# Access Compliance Report

## Public Rights-of-Way

Intersection ID: 27323	Main Street: MEADOW_RUN_LN	Cross Street: THORNHILL_CLUB_DR	Location: SE
ADA ID: 1F3DF33DC249	Ramp Type: BlendTrans1	Initial Pass/Fail: Fail	Overall Compliance: No
			Severity Score: 21.25

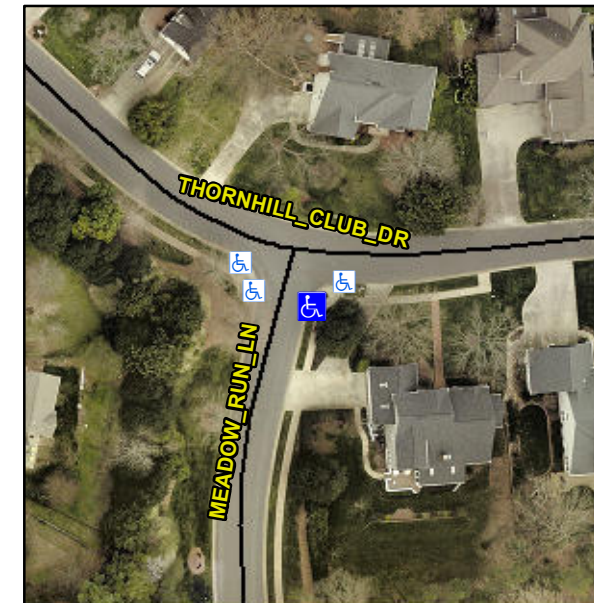
**Not Found, R304.5.1, R304.5.3**

Compliance	Description	Data	Compliance	Description	Data
N/A	Ramp Length (in)	94.0	Yes	BlendTrans Slope (%)	1.1
No	Ramp Width (in)	41.0	No	BlendTrans XSlope (%)	5.5
N/A	Flare Type LT	N/A	N/A	Flare Type RT	N/A
N/A	Flare Slope LT (%)	N/A	N/A	Flare Slope RT (%)	N/A
N/A	Flare Traversable LT?	N/A	N/A	Flare Traversable RT?	N/A
N/A	Landing Length (in)	N/A	N/A	DWS Provided?	N/A
N/A	Landing Width (in)	N/A	N/A	DWS Contrast?	N/A
N/A	Landing Slope (%)	N/A	N/A	DWS Length (in)	N/A
N/A	Landing X Slope (%)	N/A	N/A	DWS Full Width?	N/A
N/A	Landing Curb? (Y/N)	N/A	N/A	DWS Offset (in)	N/A
N/A	Shared Landing?	N/A			
N/A	Gutter Ponding?	N/A	N/A	Gutter Slope (%)	N/A
N/A	Gutter Lip Ht (in)	N/A	N/A	Gutter X Slope (%)	N/A
N/A	Painted X Walk1?	No	N/A	Painted X Walk2?	N/A
	X Walk 1 Direction	To W		X Walk 2 Direction	N/A
	X Walk 1 Width (in)	N/A		X Walk 2 Width (in)	N/A
	X Walk 1 Slope (%)	2.2		X Walk 2 Slope (%)	N/A
	X Walk 1 X Slope (%)	3.2		X Walk 2 X Slope (%)	N/A

**Remove & Replace Curb Ramp With Two New Directional Ramps or Equivalent.**
